TYPE II DEVELOPMENT & ENVIRONMENTAL REVIEW, STAFF REPORT & DECISION

Project Name: CASSIDY'S GARDEN INFILL SHORT PLAT

Case Number: PLD2008-00054; EVR2008-00070

Request: Short plat approximately .75 (.64) acres into four single-family lots using the Tier I infill standards in the R1-6 zoning district

PRELIMINARY PLAT

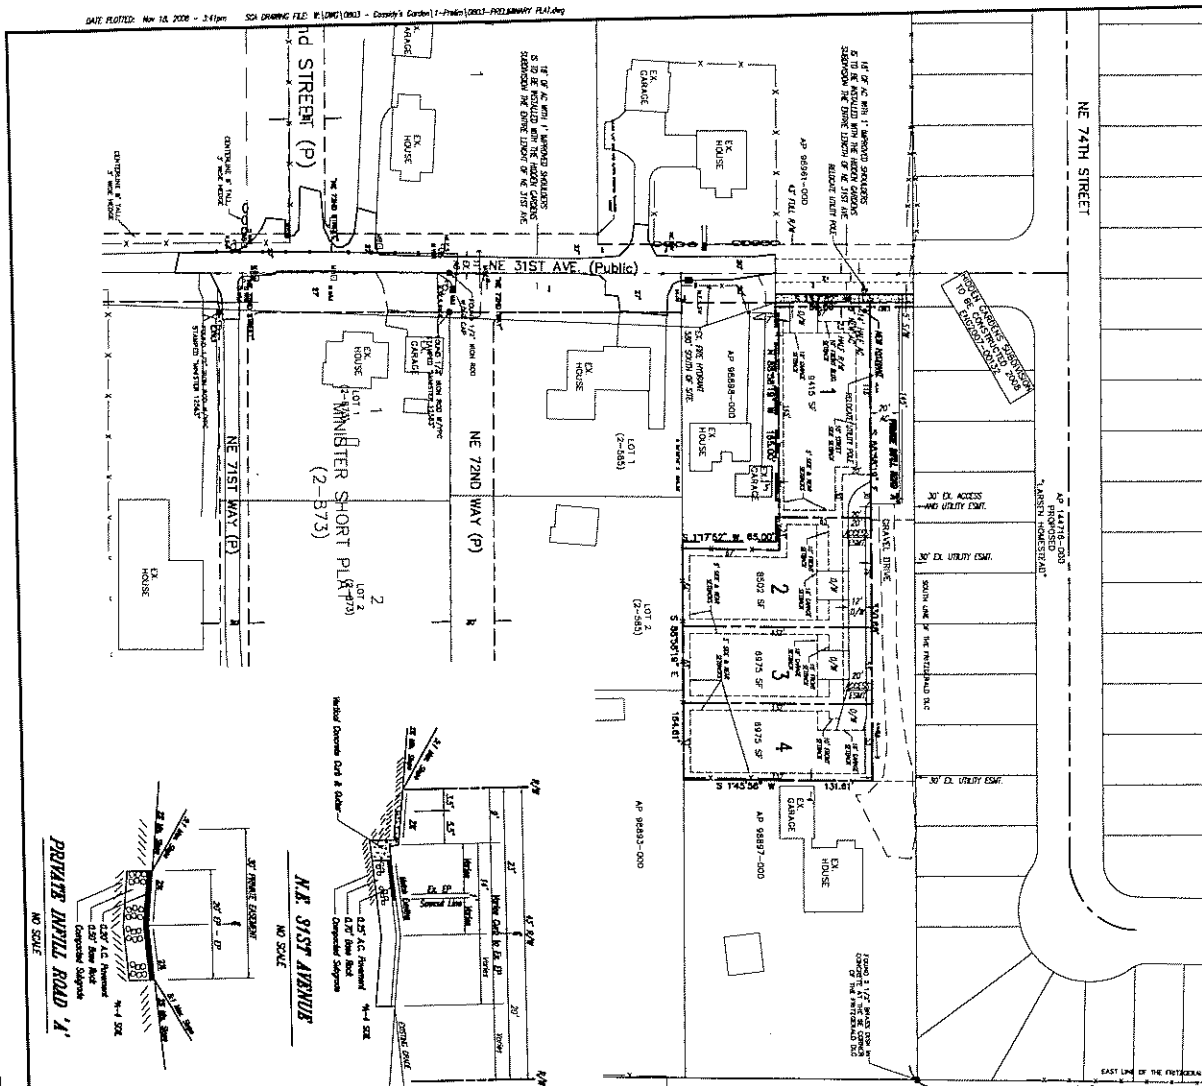
The applicant has proposed frontage improvements that are consistent with an "Urban Local Residential Access" road. The applicant shall provide minimum half-width frontage improvements including 29 feet of right-of-way dedication, 20 feet of paved roadway, curb, gutter, and sidewalk. (See Condition A-1a)

An on-site "Urban Infill A" road has been proposed. Proposed lot #1 will take access from NE 31st Avenue and the remaining lots #2 through #3 will utilize a joint driveway beginning at the terminus of the proposed private road. Intersection curb return radii shall comply with table 40.350.030-4. (See Condition A-1c)

The applicant has submitted an administrative road modification for an inverted crown for the proposed on-site private roadway. Staff supports the request and believes the design is equal or superior.

Per CCC 40.380.040(C)(1)(g), the project shall not materially increase or concentrate stormwater runoff onto an adjacent property or block existing drainage from adjacent lots. The base of the infiltration facilities shall be at a minimum of three feet above the seasonal high water or an impermeable soil layer per CCC 40.380.040(C)(3)(c). (See Condition A-3a)

Modifications made to standard details D16.0 and D16.1 shall be stamped by a professional engineer that is proficient in geotechnical engineering. (See Condition A-3b)

- a. The applicant shall provide minimum half-width frontage improvements including 29 feet of right-of-way dedication, 20 feet of paved roadway, curb, gutter, and sidewalk.

- c. Intersection curb return radii shall comply with table 40.350.030-4.
 - d. Per CCC 40.350.030 (B)(4)(b)(1)(b), corner lot driveways shall be a minimum separation of 50 feet from the intersecting property lines or where this is impractical, the driveway may be located 5 feet from the property line away from the intersection or as a joint use driveway at this property line.

- a. Per CCC 40.380.040(C)(1)(g), the project shall not materially increase or concentrate stormwater runoff onto an adjacent property or block existing drainage from adjacent lots. The base of the infiltration facilities shall be at a minimum of three feet above the seasonal high water or an impermeable soil layer per CCC 40.380.040(C)(3)(c).

- b. Modifications made to standard details D16.0 and D16.1 shall be stamped by a professional engineer that is proficient in geotechnical engineering.
